Our Reference: 21_82_CPPL_EDCP_DD

Subject: 1111-1141 ELIZABETH DRIVE SUBDIVISION, CECIL PARK (SSD 8859) ACCESS CONCEPT DESIGN

Appendix A – Latest Access Concept Design

Appendix B – TfNSW latest review comments on the preliminary design submitted by MU Group

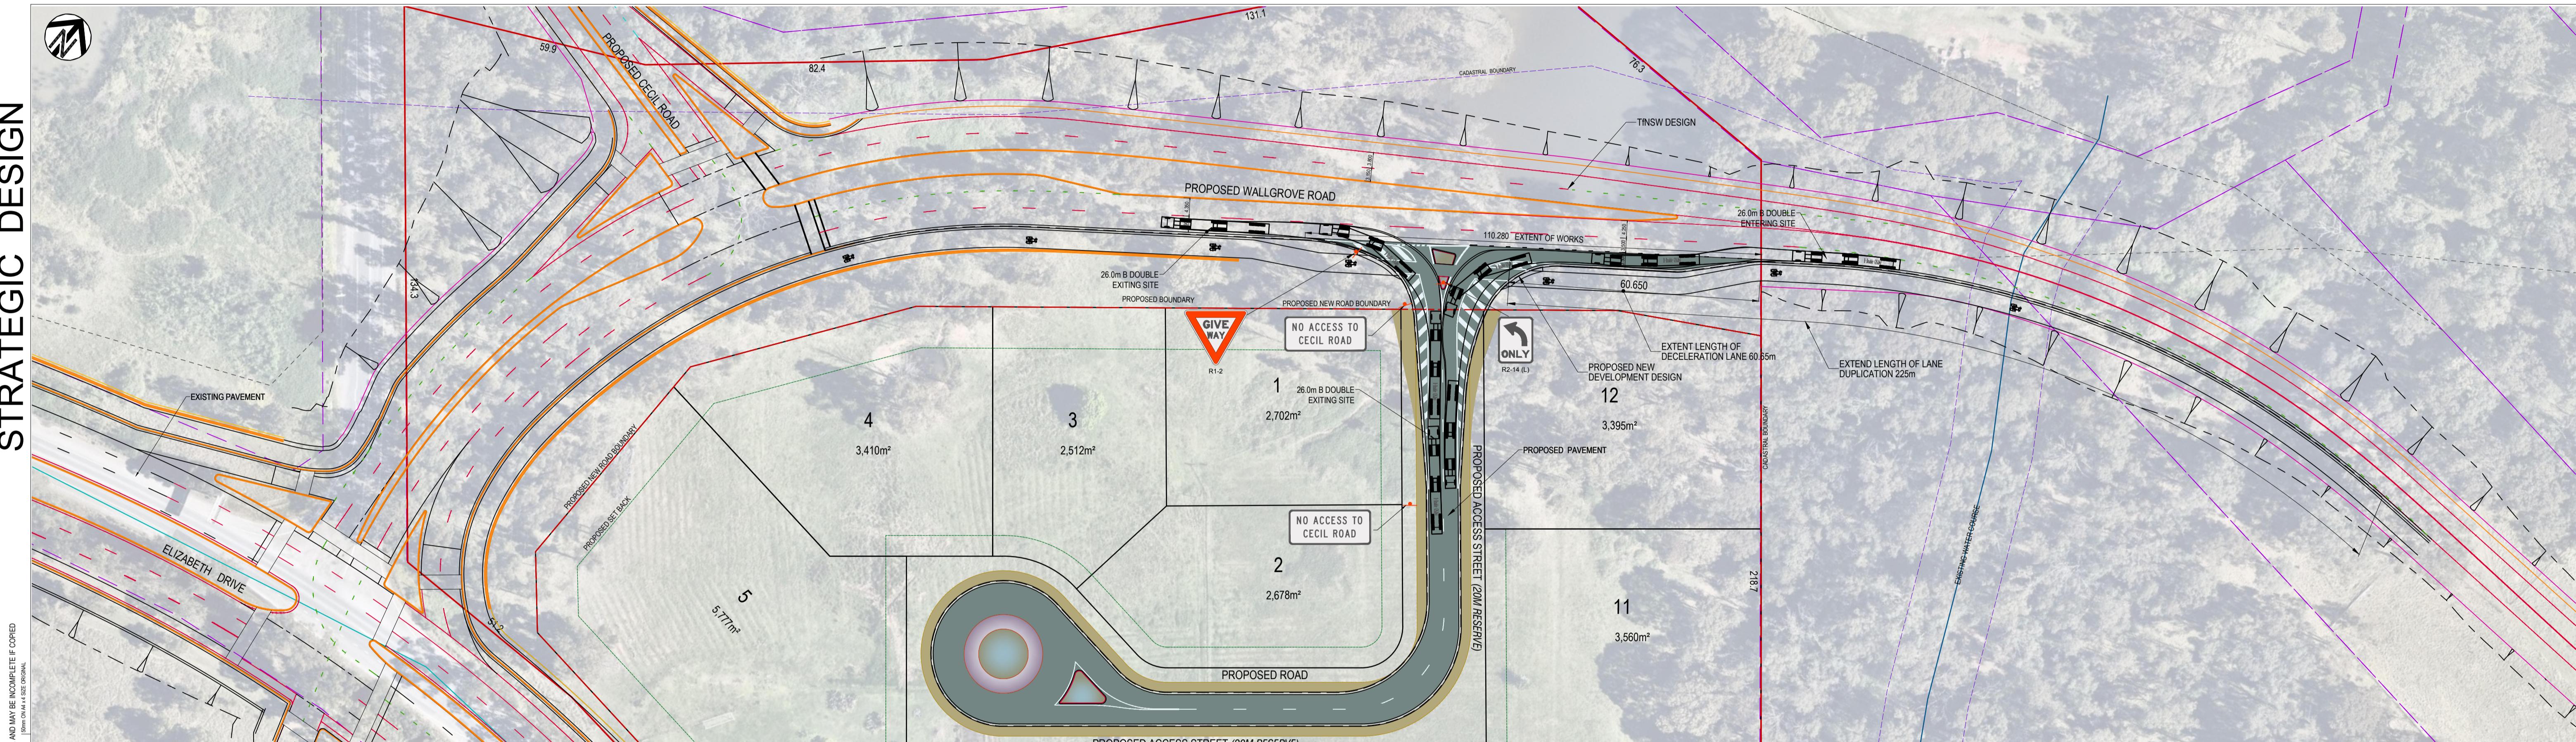
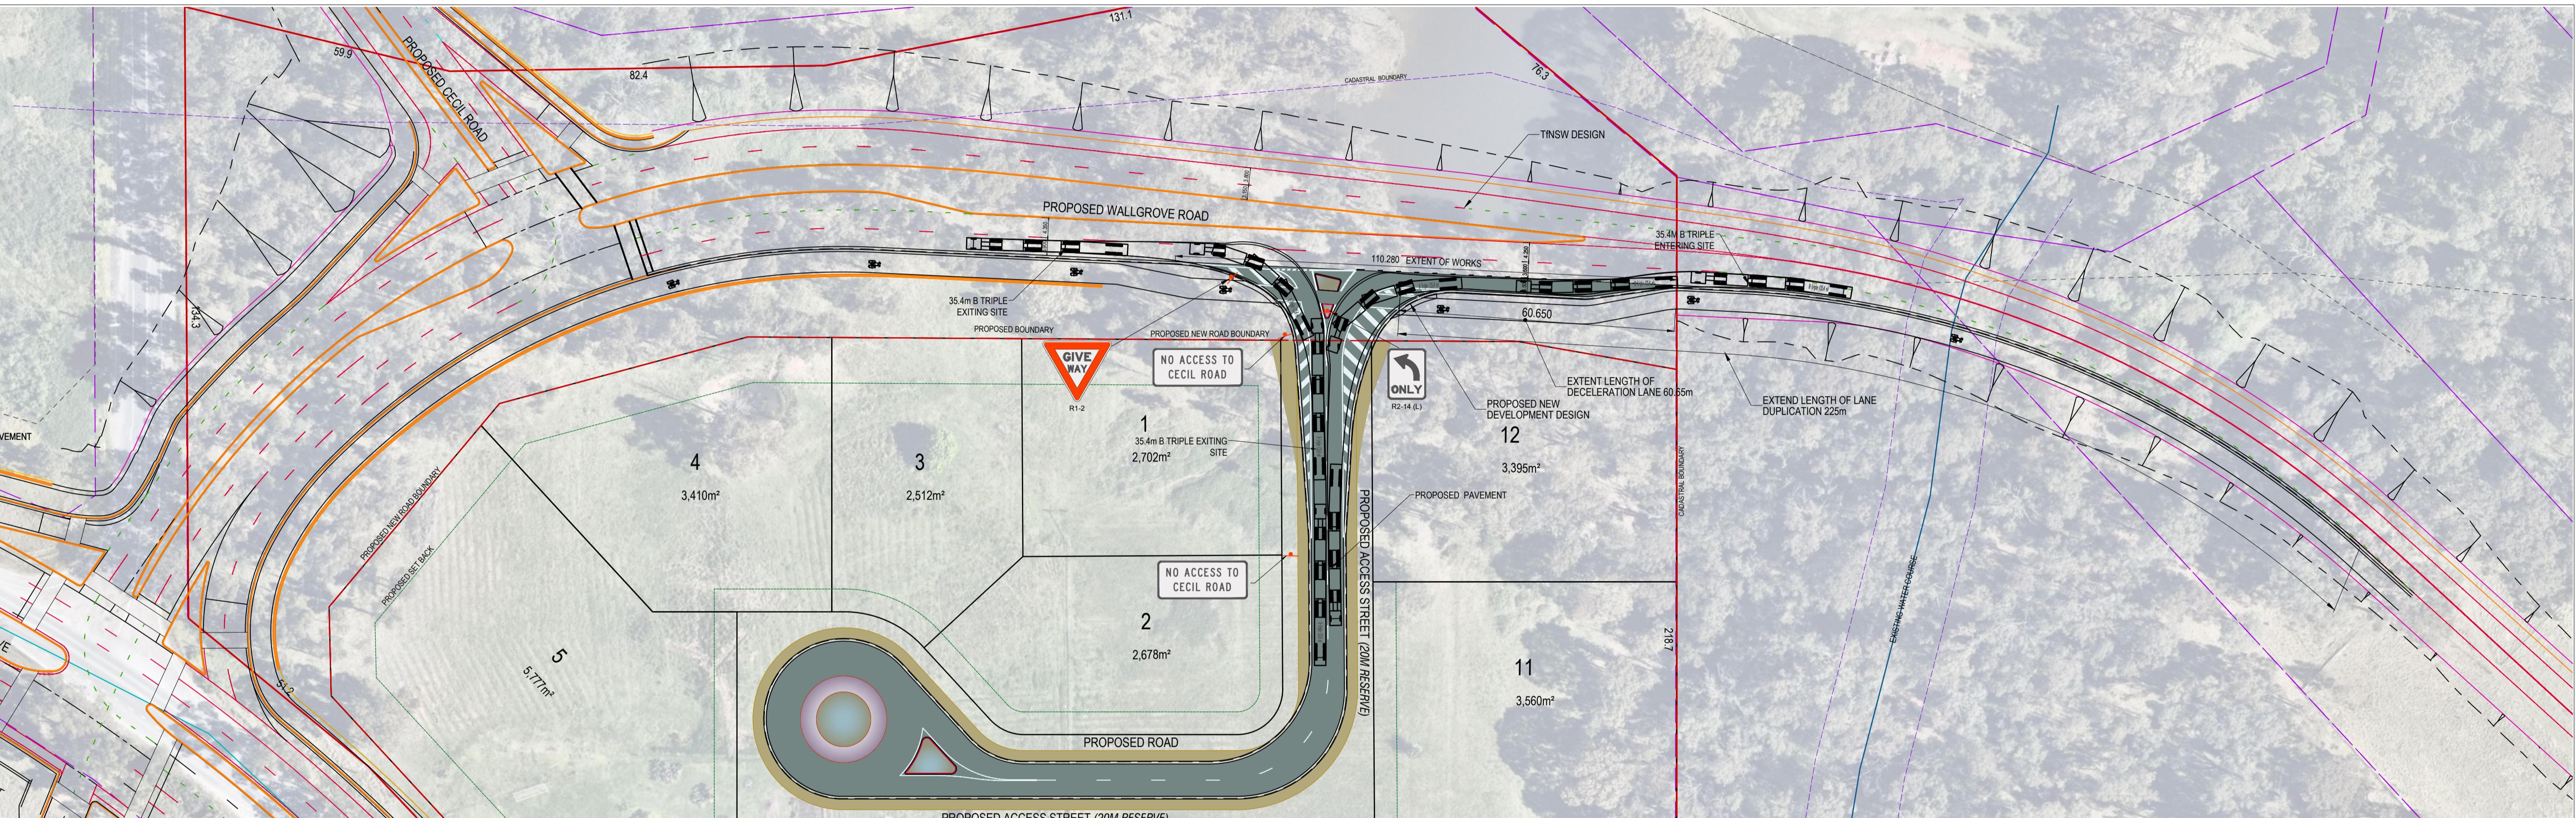
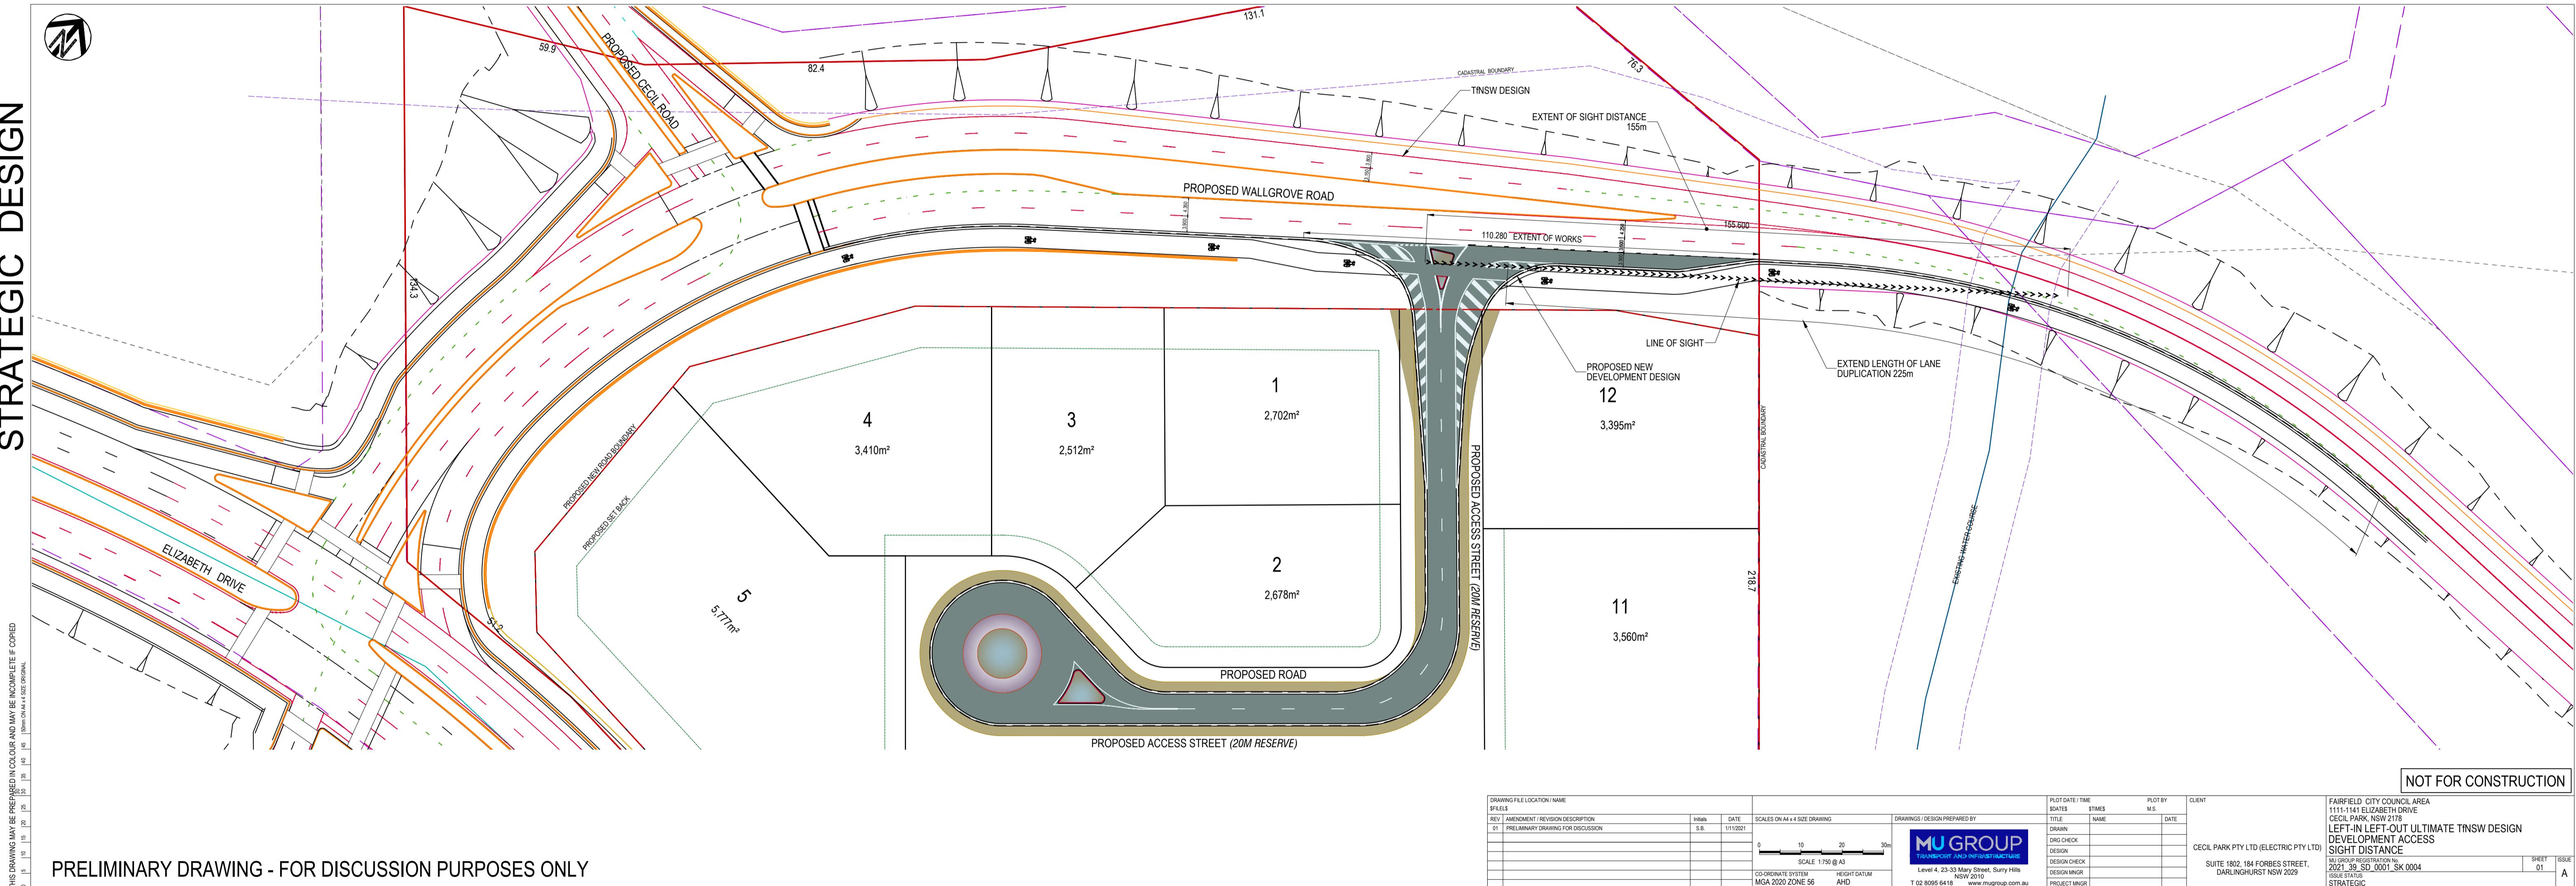
Review Comments	MU Group Response
TfNSW latest review comments (dated 22 November 2021) on the preliminary design submitted by MU Group to TfNSW. Refer to Appendix B.	
<p>a. It is requested that a deceleration lane should be provided at the frontage of the subject site for access arrangement. The deceleration should be located wholly within the property and dedicated as public road.</p>	<p>A deceleration lane contained wholly within the site has been provided in the latest design included in Appendix A.</p>
<p>b. The proposed left in/left out and deceleration lane including the length of the deceleration lane should be in compliance with AUSTROADS and for the design speed listed above.</p>	<p>The deceleration lane has a length of 61m, which complies with Austroads.</p> <p>Note that <i>Austroads, Part 4a, Section 5.2 Deceleration Lanes</i>, requires a deceleration lane length of 60m based on design speed of 70km/h and exit speed of 30km/h.</p>

<p>c. Plans including the swept path analysis should be modified to reflect the above requirement.</p>	<p>Swept Paths analysis for 26m B-Doubles and 35m B-Triples are included in Appendix A</p>
<p>d. TfNSW queried on 25 November 2021 over the phone on the presence of OSD for the site.</p>	<p>The development site has an Onsite Detention in accordance with Fairfield City Council requirements.</p>
TfNSW correspondence (dated 12 November 2020). Refer to Appendix C.	
<p>a. The proposed access to the site on the new realigned Wallgrove Road is located around a bend and TfNSW raises safety concerns with the sight distance at the proposed access road. A sight distance assessment should be provided to demonstrate the required sight distance is achieved.</p>	<p>Sight distance check has been undertaken included in Appendix A.</p> <p>The sight distance check confirms that the required sight distance of 151m (<i>Table 3.2 of Austroads Guide to Road Design Part 4A</i>) for a design speed of 70m/h is achieved.</p>

The attached plan has been reviewed and it is requested that a deceleration lane should be provided at the frontage of the subject site for access arrangement. The deceleration should be located wholly within the property and dedicated as public road.

The proposed left in/left out and deceleration lane including the length of the deceleration lane should be in compliance with AUSTROADS and for the design speed listed above.

Plans including the swept path analysis should be modified to reflect the above requirement.

Figure 3.2: Safe intersection sight distance (SISD)

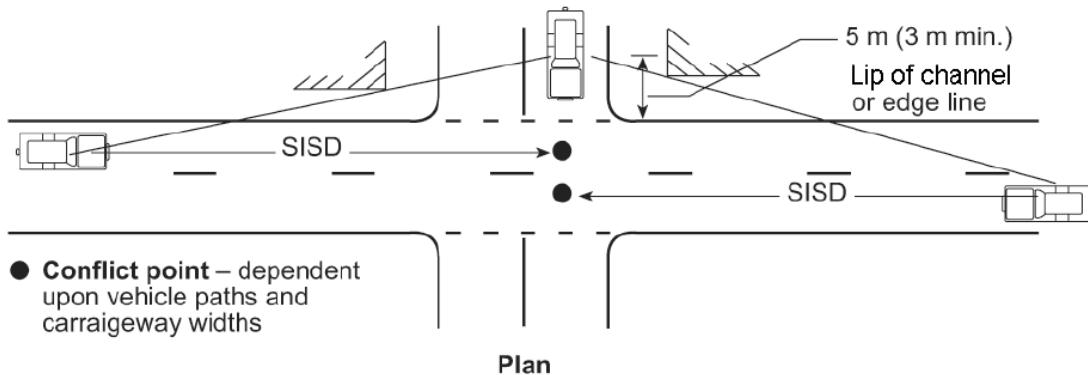
c. The proposed access to the site is uncontrolled and the potential for conflict is high due to it being at a point where drivers are merging and diverging.

Reference to Austroads *Guide to Road Design Part 4A: Unsignalised and Signalised Intersections*, Section 3.2.2 sets out the design requirements for SISD, which is the minimum sight distance which should be provided on the major road at any intersection. Diagrammatically, SISD is illustrated in the Austroads extract below.

See Response to a) and b) above.

5 Road Safety Risks

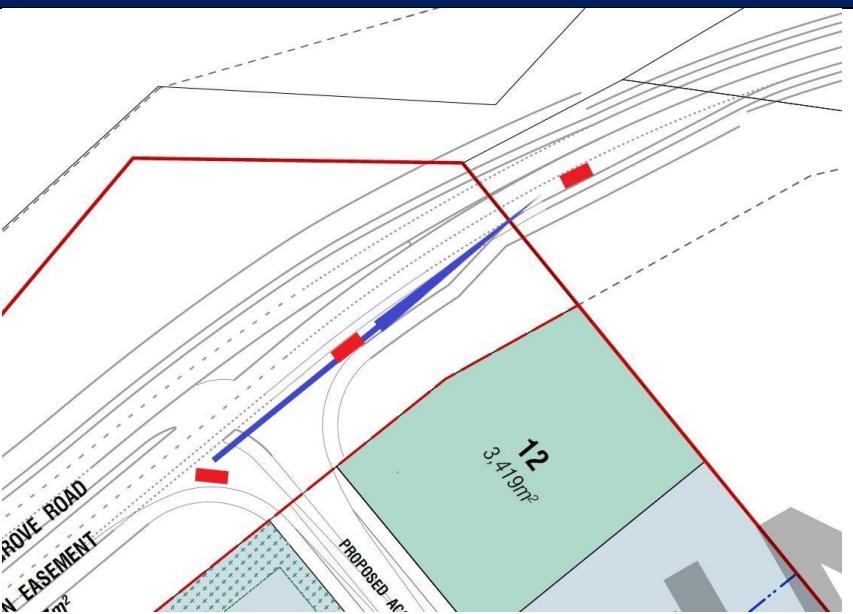
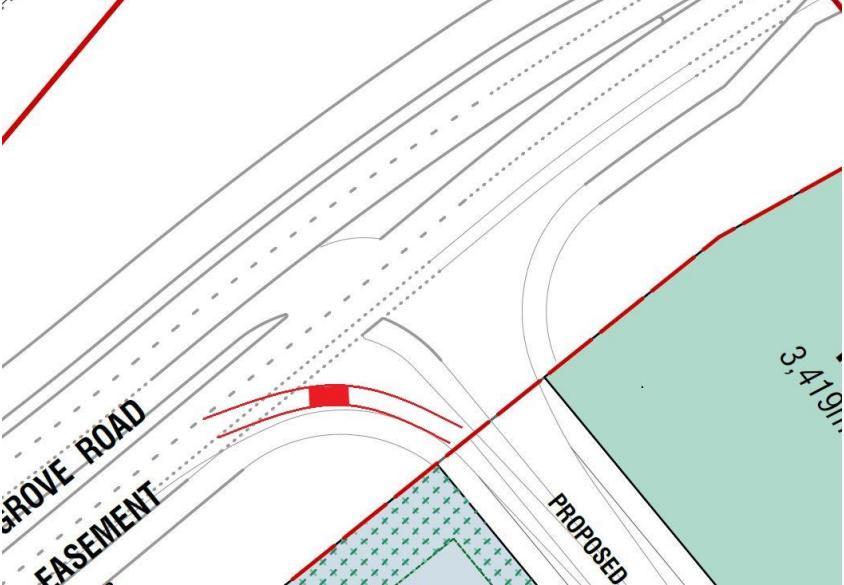
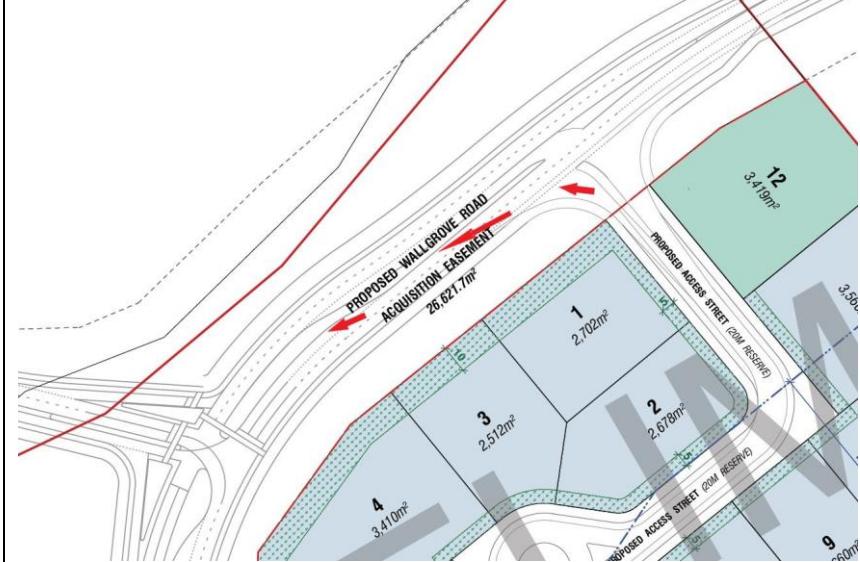
Ref No.	Photos / Site Description / Safety Issue	Description of risk to road safety (Reason why this is a safety issue)	Road Safety Audit Category	Probability	Severity	Risk Rating
1	 <p>Design plan showing left turning vehicle from proposed site access.</p> <p>Austroads requirement (Guide to Road Design Part 4A, Table 3.2) for SISD at 70km/h: 151m</p> <p>SISD Achieved in current design with left turning vehicle: 84m</p> <p>SISD Achieved in current design with left turning vehicle: 150m</p>	<p>Safe intersection sight distance for left turning vehicles out of the access road is not achieved to southbound vehicles in Wallgrove Road. Drivers may become impatient and pull out into the southbound travel lane on Wallgrove Road with insufficient gaps in the traffic causing rear-end and intersection type crashes. This issue could be exacerbated by the vertical alignment on Wallgrove Road (not assessed under this safety audit) as well as the presence of vehicles turning left into the development.</p> <p>It is noted that other options have proposed an intersection further north on Wallgrove Road. This does not improve the safety risk described above due to the presence of the horizontal curve in Wallgrove Road and the terminating leg of the T-intersection being on the inside of the curve.</p>	Intersections	Yearly	Serious	Medium

Ref No.	Photos / Site Description / Safety Issue	Description of risk to road safety (Reason why this is a safety issue)	Road Safety Audit Category	Probability	Severity	Risk Rating
2	 <p data-bbox="287 975 1109 1054"><i>Design plan showing left turning vehicle following kerb line and stopping at the give way line.</i></p>	<p data-bbox="1154 374 1641 879">The width and kerb return radii at the access road exit appears to be excessive. This will result in vehicles stopping at the give way line at an undesirable angle to oncoming traffic, increasing the likelihood of crashes highlighted in Risk 1. Drivers may also attempt to turn two abreast given the significant width at the intersection or illegally make a right turn out of the proposed access road resulting in right-through and rear-end crashes.</p>	Intersections	Yearly	Serious	Medium

Ref No.	Photos / Site Description / Safety Issue	Description of risk to road safety (Reason why this is a safety issue)	Road Safety Audit Category	Probability	Severity	Risk Rating
3	 <p><i>Design plan showing vehicle path from the site access to the right turn bay for Cecil Road.</i></p>	<p>Turning left out of the development access road and right into Cecil Road requires attaining a suitable gap in the southbound traffic on Wallgrove Road and then changing across one lane to enter the right turn bay. The distance available to carry out this sequence of manoeuvres is insufficient, and drivers may have to force their way through. This disruption to the traffic flow may be worsened if the right turn bay has several vehicles already waiting in it. Rear-end and lane change crashes could occur as a result of this geometry.</p>	Intersections	6 Monthly	Moderate	Low
